Serial: RNP-RA/02-0067

H. B. ROBINSON STEAM ELECTRIC PLANT, UNIT NO. 2
DOCKET NO. 50-261/LICENSE NO. DPR-23

REQUEST FOR TECHNICAL SPECIFICATIONS CHANGE REGARDING
FULL IMPLEMENTATION OF ALTERNATIVE RADIOLOGICAL SOURCE TERM

Figure 3.4.16-1
Reactor Coolant DOSE EQUIVALENT I-131 Specific Activity
Limit Versus Percent of RATED THERMAL POWER

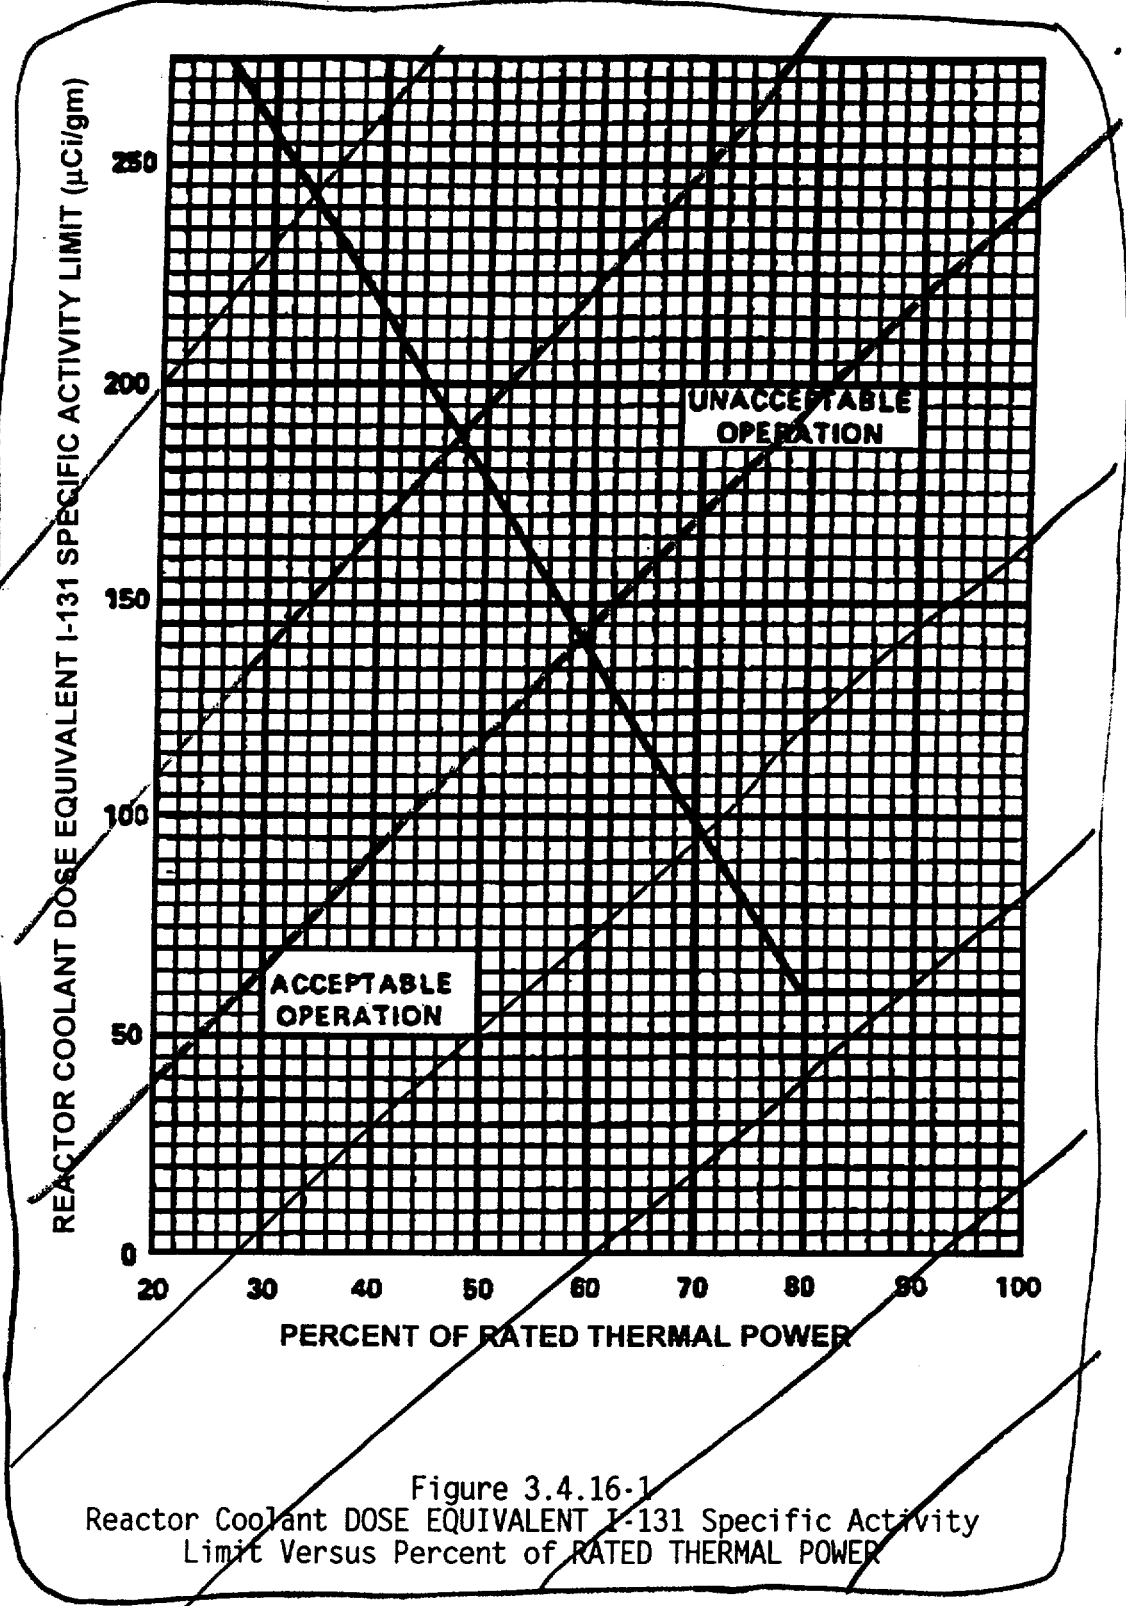
The Dose Equivalent I-131 requirements of TS 3.4.16, "RCS Specific Activity," are reduced from 1.0 $\mu\text{Ci/gm}$ to 0.25 $\mu\text{Ci/gm}$ in Condition A and in Surveillance Requirement (SR) 3.4.16.2. In addition, Figure 3.4.16-1, "Reactor Coolant Dose Equivalent I-131 Specific Activity Limit Versus Percent of Rated Thermal Power," is deleted. Required Action A.1 is revised to replace the reference to the acceptable region of Figure 3.4.16-1 with a limit of $\leq 60.0 \mu\text{Ci/gm}$. The second entry condition of Condition C is revised to replace the reference to the unacceptable region of Figure 3.4.16-1 with reference to $> 60 \mu\text{Ci/gm}$.

The Dose Equivalent I-131 requirements of TS 3.4.16, "RCS Specific Activity," are reduced from 1.0 $\mu\text{Ci/gm}$ to 0.25 $\mu\text{Ci/gm}$ in Condition A and in Surveillance Requirement (SR) 3.4.16.2. In addition, Figure 3.4.16-1, "Reactor Coolant Dose Equivalent I-131 Specific Activity Limit Versus Percent of Rated Thermal Power," is deleted. Required Action A.1 is revised to replace the reference to the acceptable

region of Figure 3.4.16-1 with a limit of $\leq 60.0 \mu\text{Ci/gm}$. The second entry condition of Condition C is revised to replace the reference to the unacceptable region of Figure 3.4.16-1 with reference to $> 60 \mu\text{Ci/gm}$.
